# Wylfa Newydd Project

## Horizon's Response to Written Representation - Natural Resources Wales

PINS Reference Number: EN010007

18 December 2018

**Figure 169: A worst case end of model simulation: a 1 in 2 storm with a 1 in 30 storm event part way through (no wind or waves) construction drainage suspended solids concentration (kg/m<sup>3</sup>).**

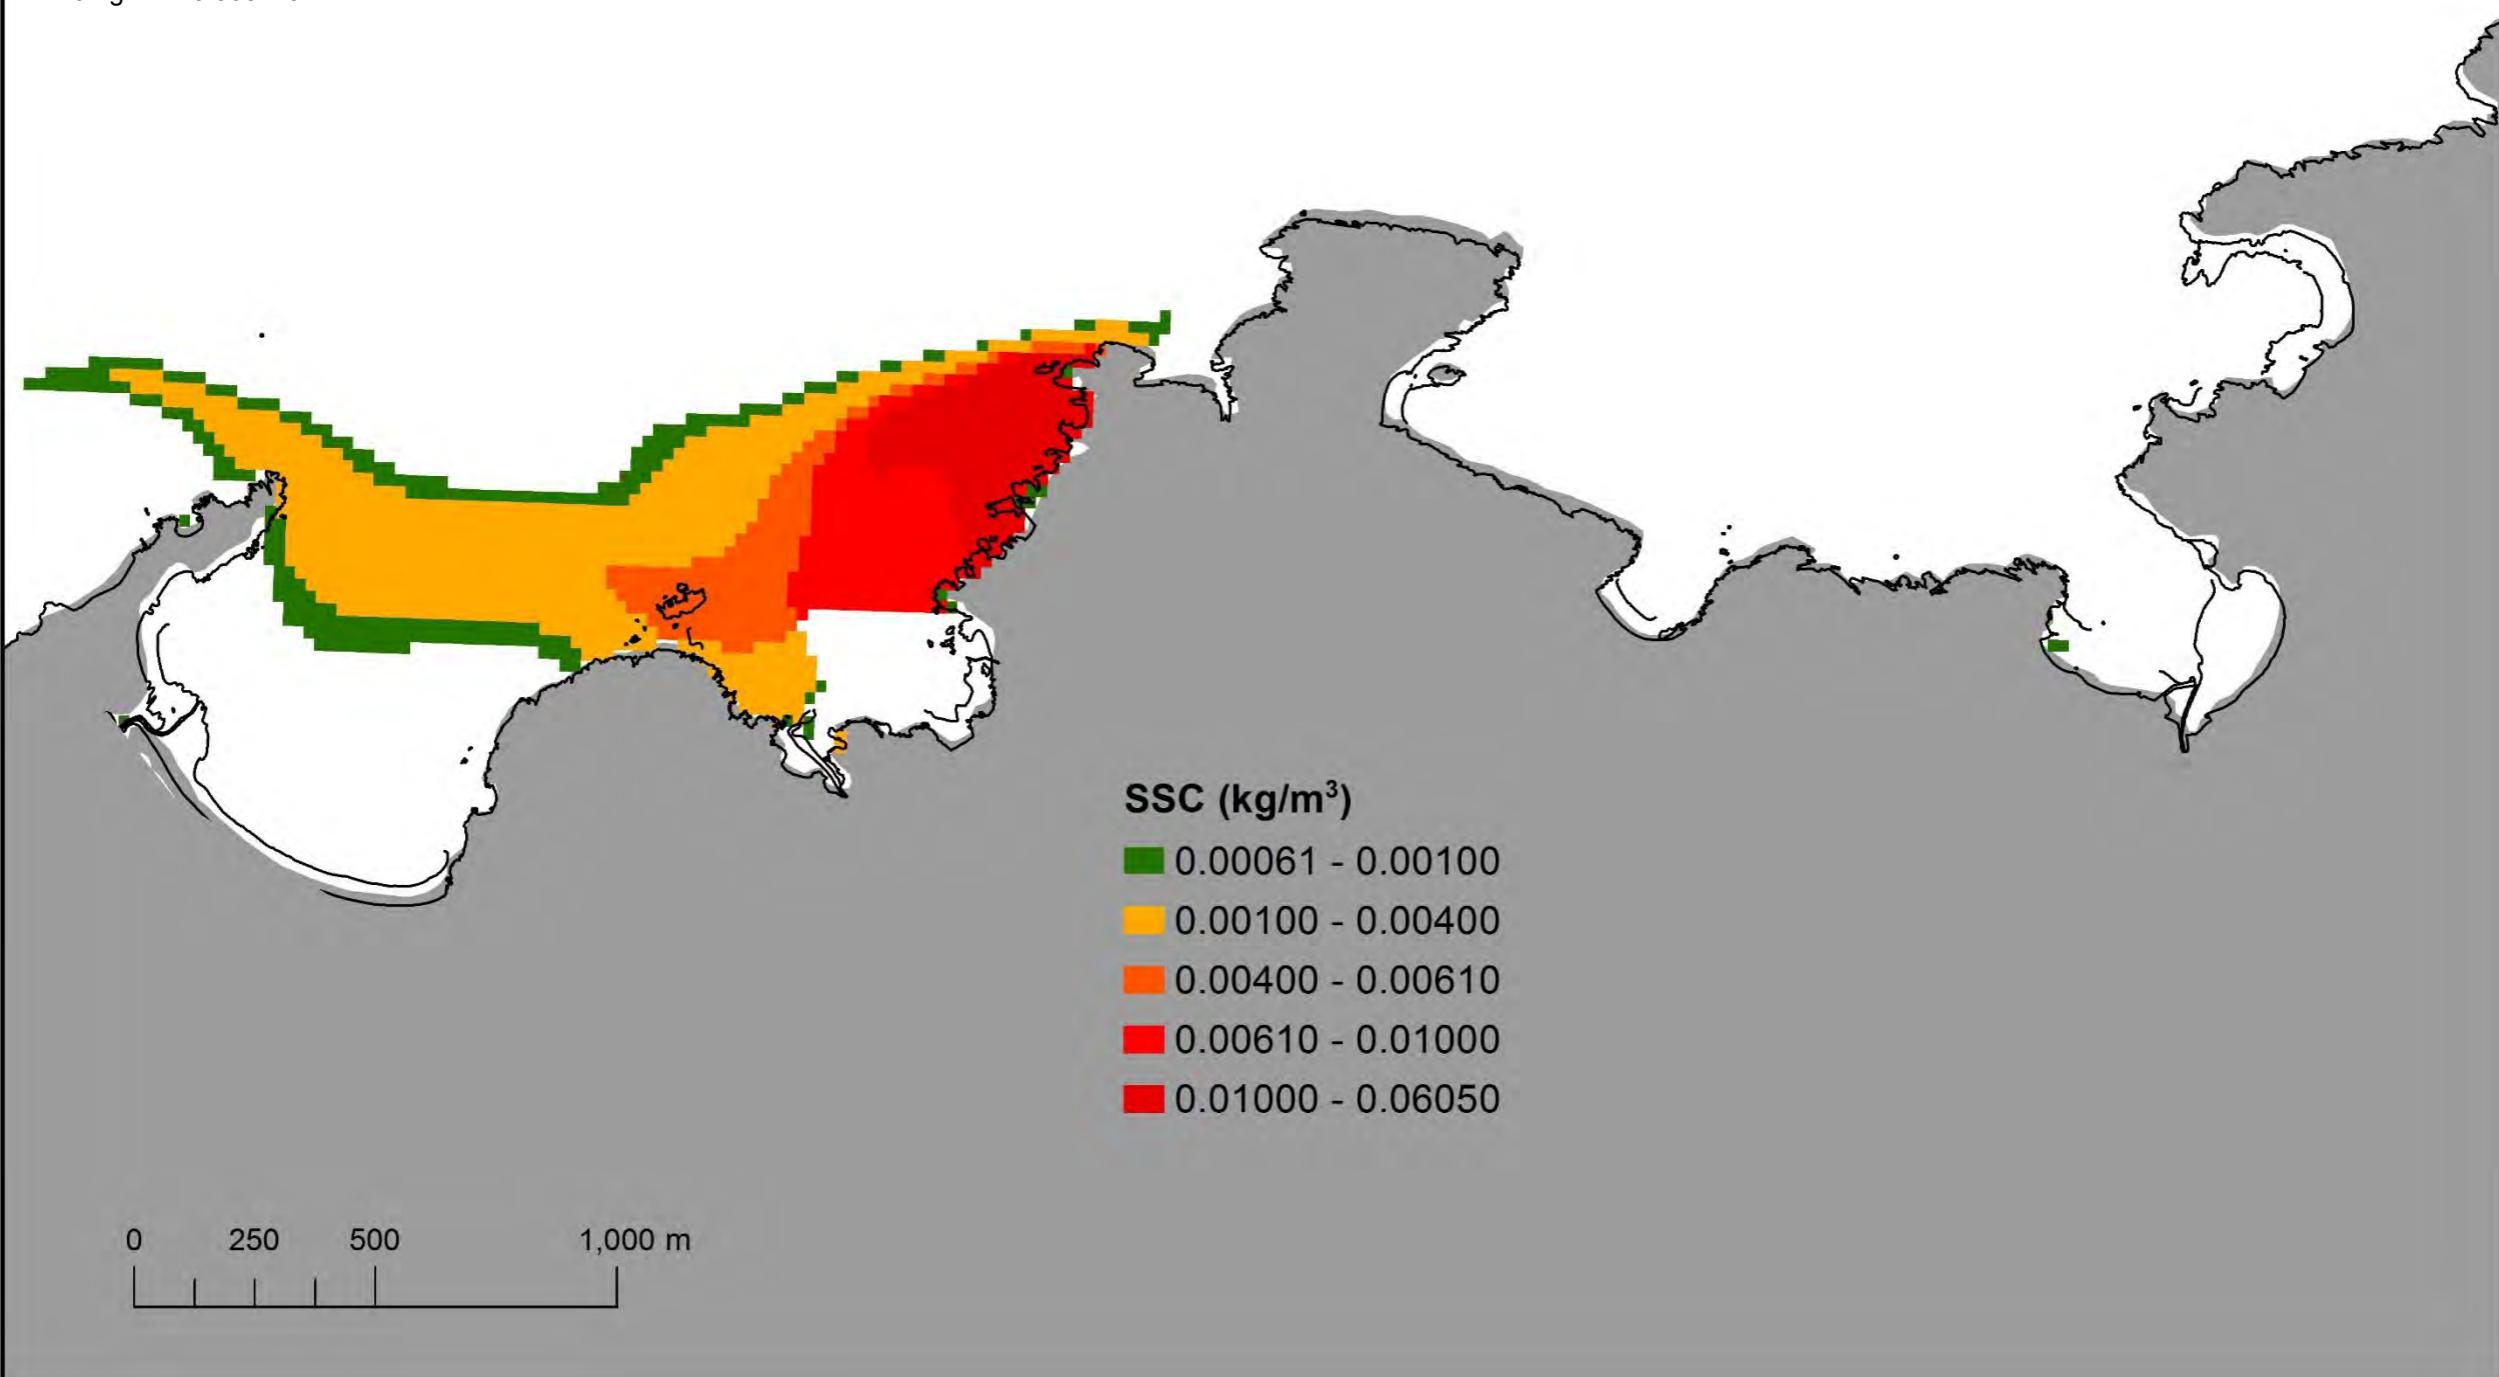
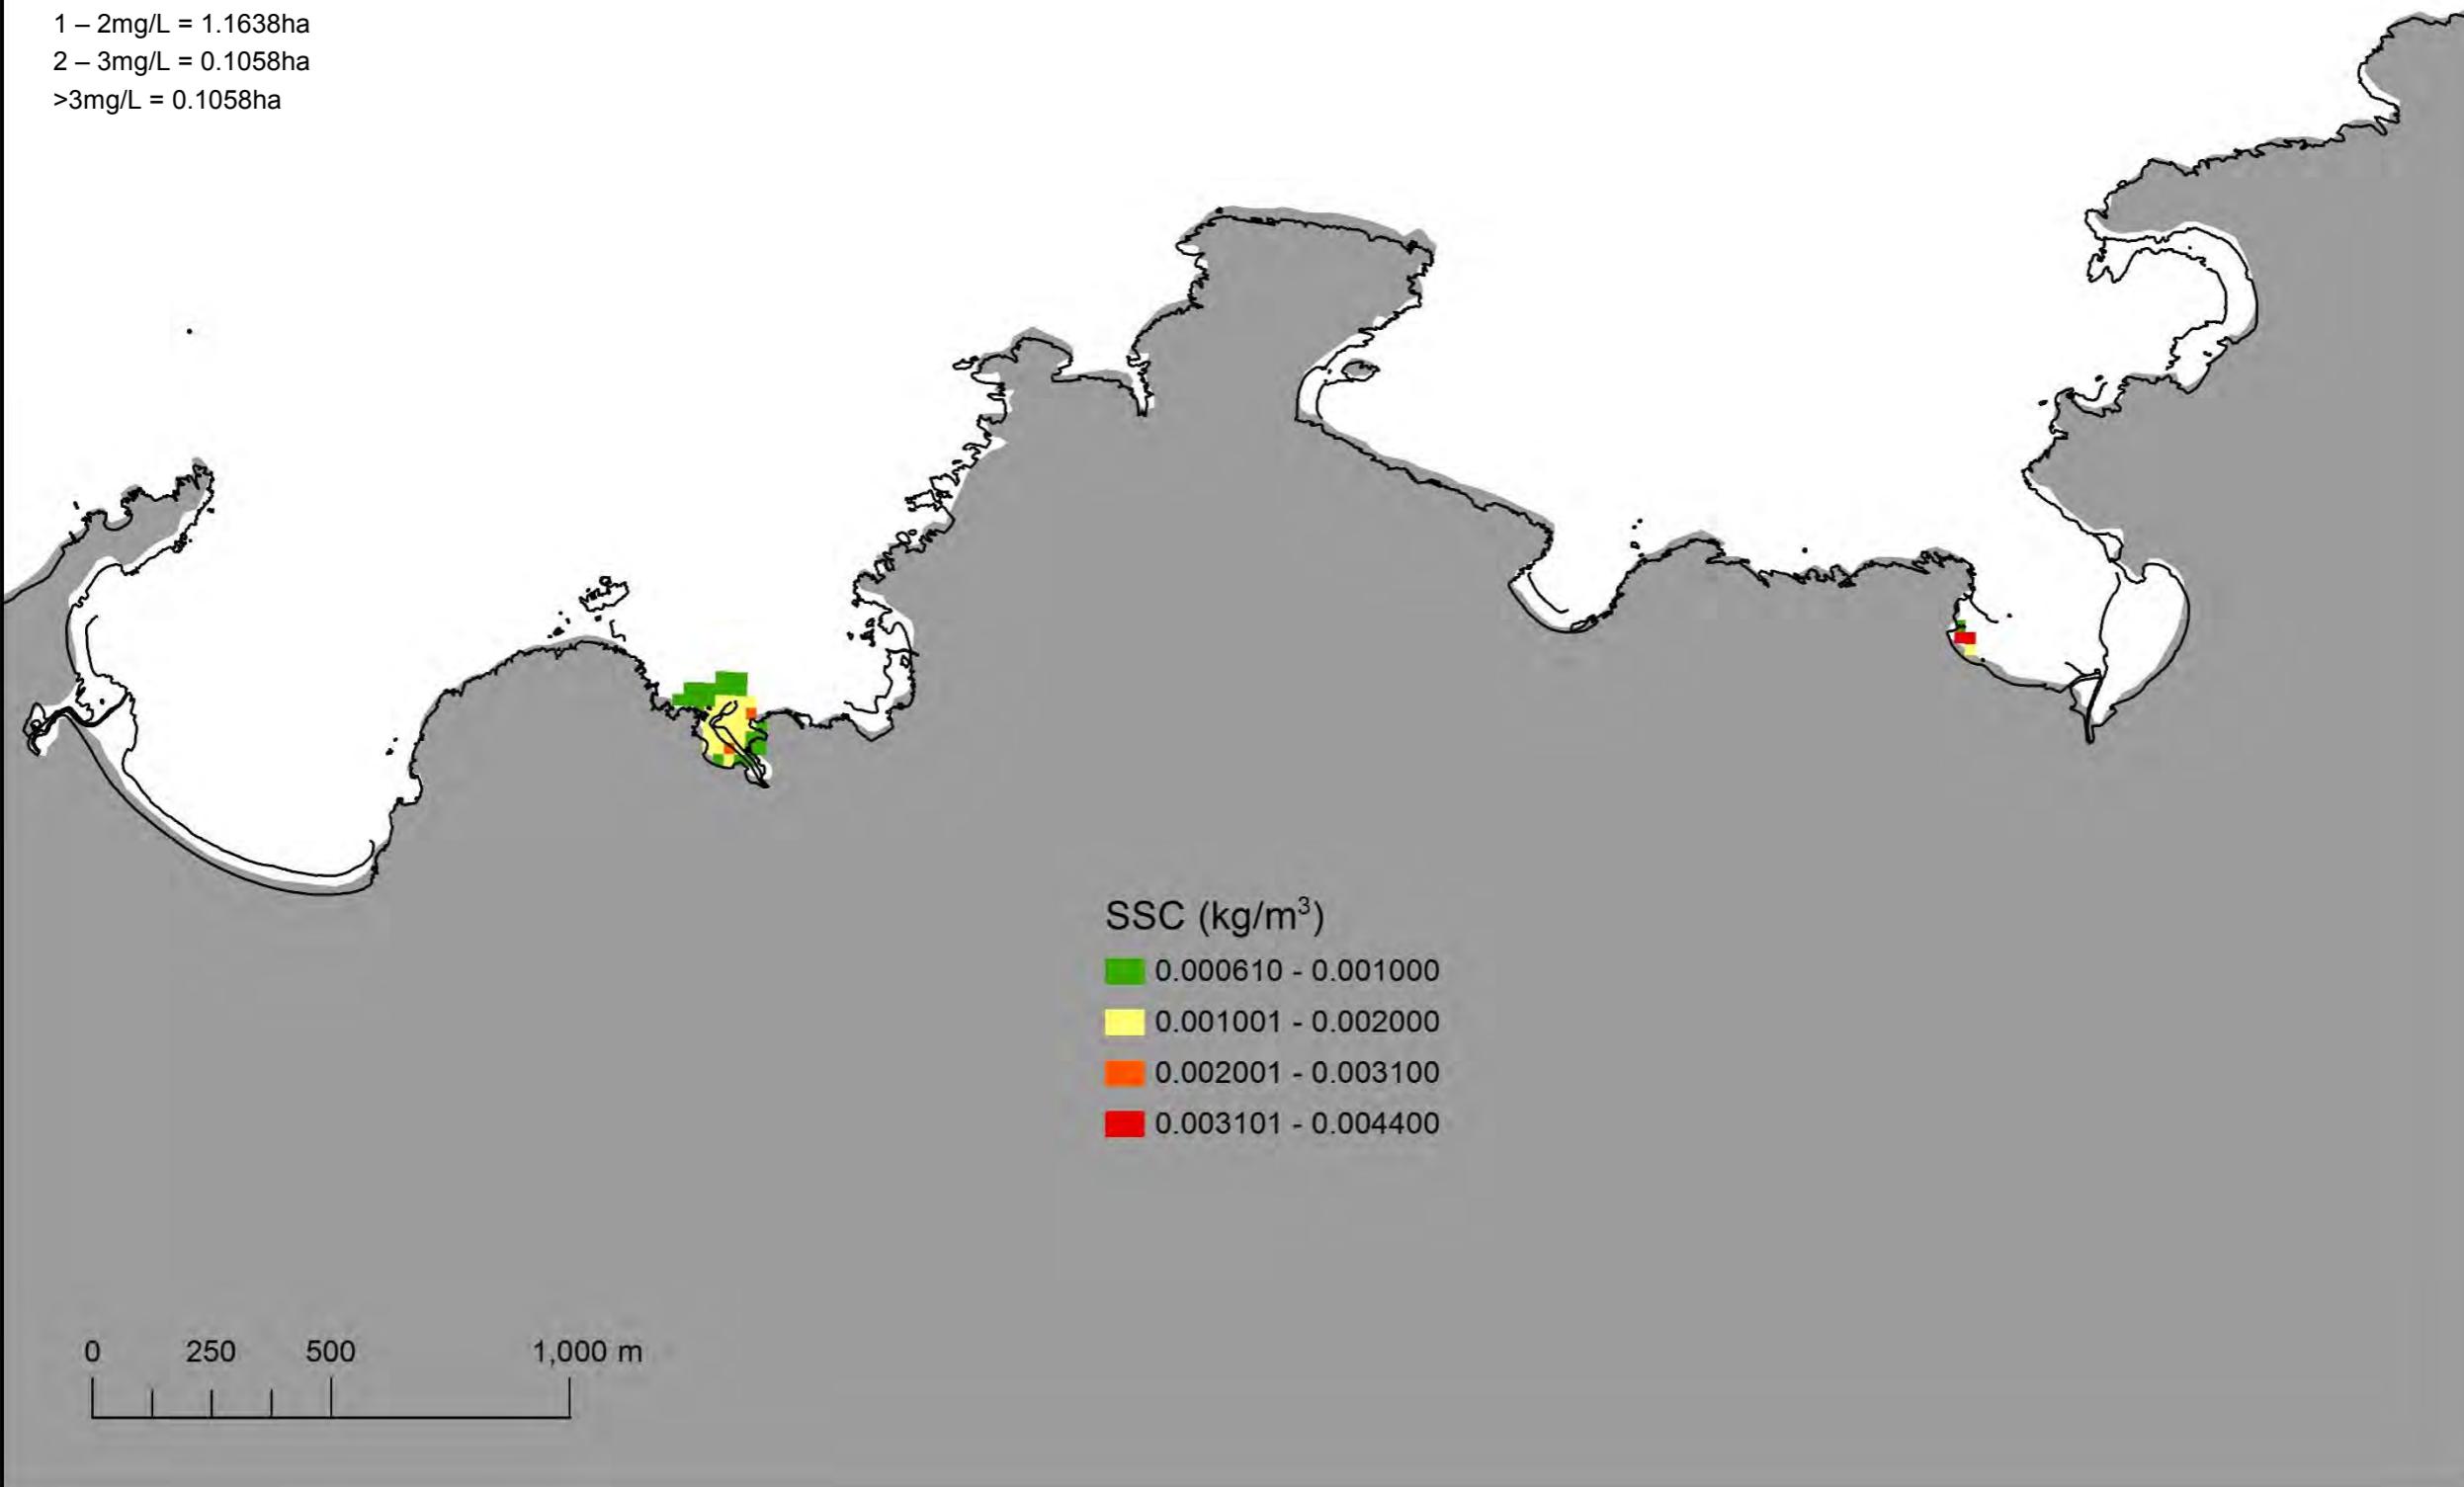
7.30.21 As agreed with NRW in the context of discussions regarding the Environmental Permit application, Horizon has prepared revised figures and recalculated the areal extent of change above a 10% background (0.61mg/L total suspended solids loading) as agreed. This data is provided in Appendix A to this document. The total suspended solid plots presented in figures 164; 165; 166; 169 & 170 in appendix D13.08 [APP-226] show the increase in suspended solid concentrations for the Wylfa Newydd DCO Project. These plots have been updated in Appendix A to show suspended solid increases above 10% of background (i.e. >0.61 mg/L total suspended solids) and areal extent.
